ADDENDUM NO. 4

DATE: April 13, 2011

Contract 11-C-00033; Alline Avenue Stormwater Pump Station

WO# 5103
 SHEET
 E-5

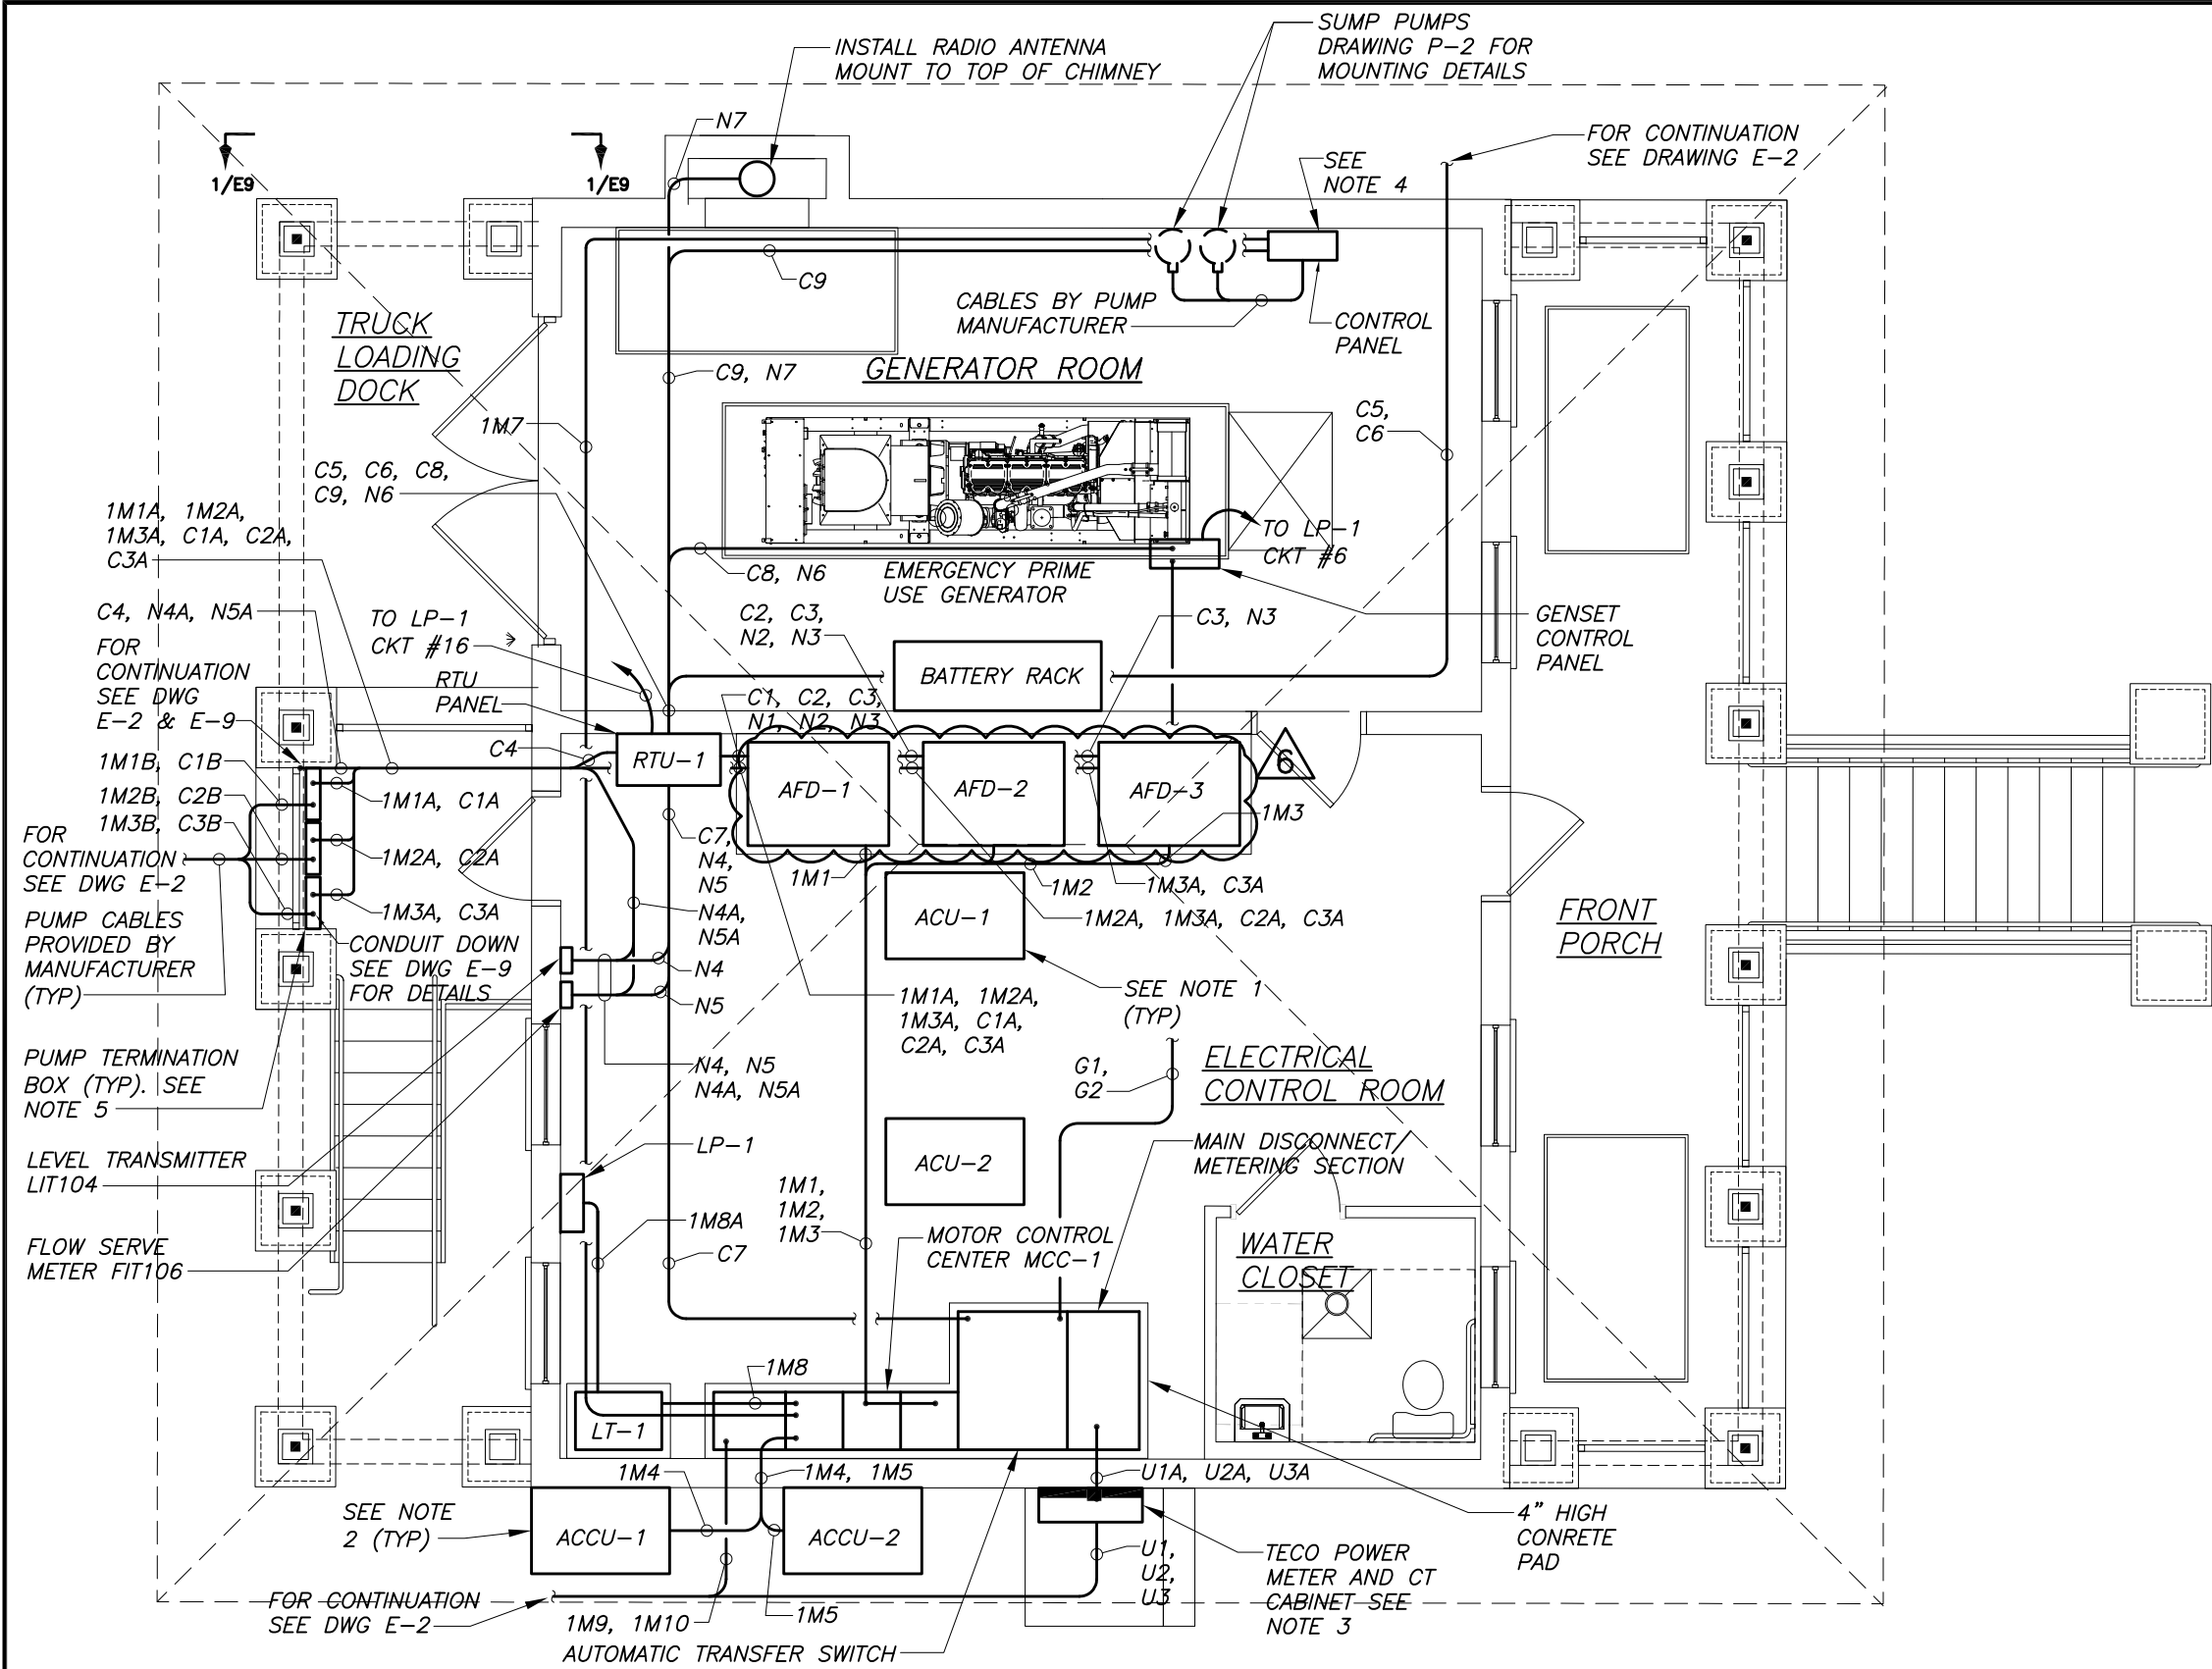
- Item 1: Replace Section 16266 with the pdf attached hereto entitled 11-C-33 add4 Sec16266.
- Item 2: Replace Plan Sheet E5 with the attached Sheet E.5.
- Item 3: Replace page P-4R with the attached page P-4RR.
- Item 4: Add, to page C-17, the following:

No.	DATE	REVISIONS
6	Apr., 2011	Addendum #4 - Resize AFD Enclosures
5	Feb., 2011	Issue For Bid
4	Jan., 2011	100% Submittal
